THE CITY OF WALTHAM
MASSACHUSETTS

ADA Bathroom Adaptation, 2020

ADDENDUM NO. 3

July 10, 2020

Q7. If the urinals and water closets are being lowered, all waste pipes will need to be re-worked in the walls. Please advise.

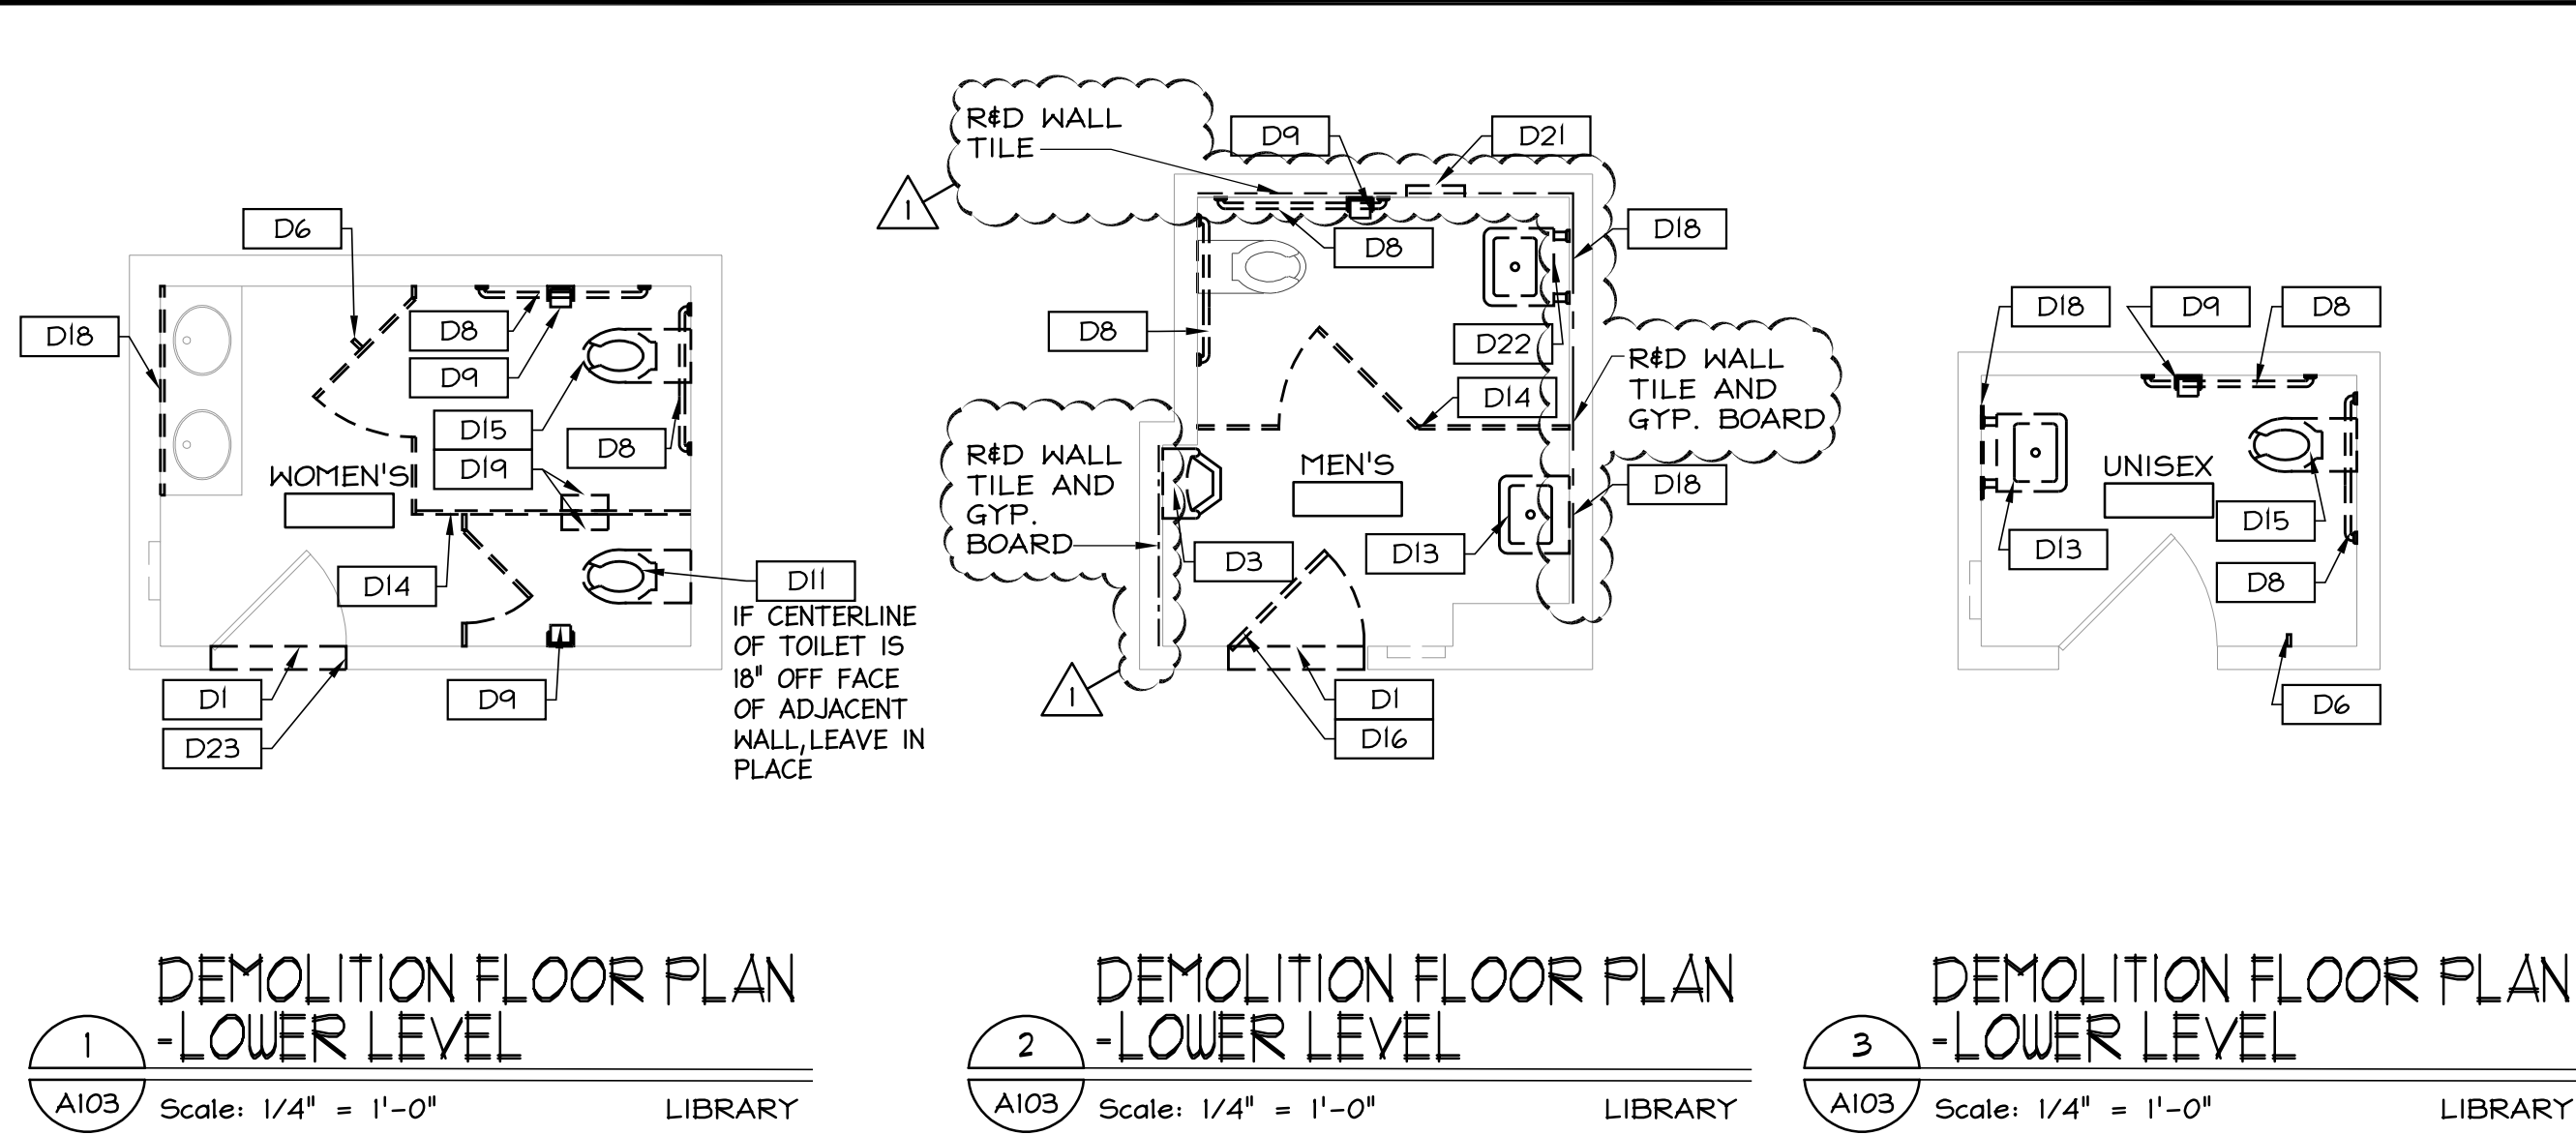
Q4. Plan A103, children's bathroom shows a chase on the demo plan. During the walk-through it is to believe there is a structural post supporting the large beam above the ceiling. Please advise

Q5. Plan A103, children's bathroom shows the wall to be extended out, there is a sprinkler head and light fixture that will need to be relocated. Please advise

Q6. Plan A103, will any additional lighting be added to children's bathroom?

If the tile color cannot be matched exactly, is a similar color acceptable or will the entire wall need to re-tiled?

A4. See attached drawings

A5. See attached drawings

A6. See attached drawings
